SEWAGE DISPOSAL SYSTEM

MARYLAND STATE DEPARTMENT OF HEALTH

SUBDIVISION Walter Rydzewski Property ROAD 11743 Bragdon Woods Dr. LOT Map 29 Parcel 45

42659

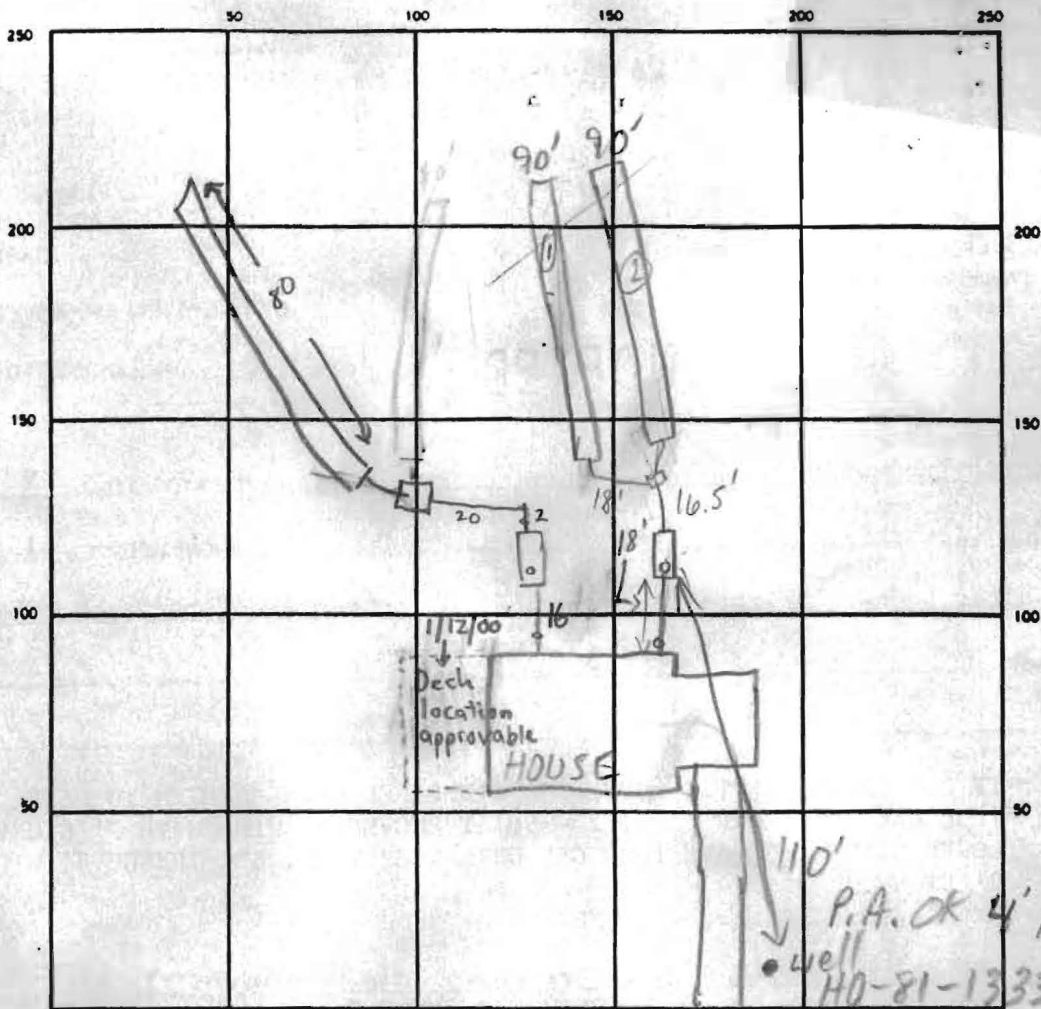
REMARKS 4/19/90 #1 HOUSE PLUMBING DOES NOT SEEM TO ALLOW
INSTALLATION OF SYS. PER SPECS (TOO LOW); S.T. FOR MAIN
SYS SET AT DIFF LOC., SOME SDA AREA LOST; DB FOR
EACH SYS. RESET AS BOTH DB'S WERE TOO LOW ALSO MR
4/19/90 #2 OK TO COVER MAIN SYS. WHEN READY
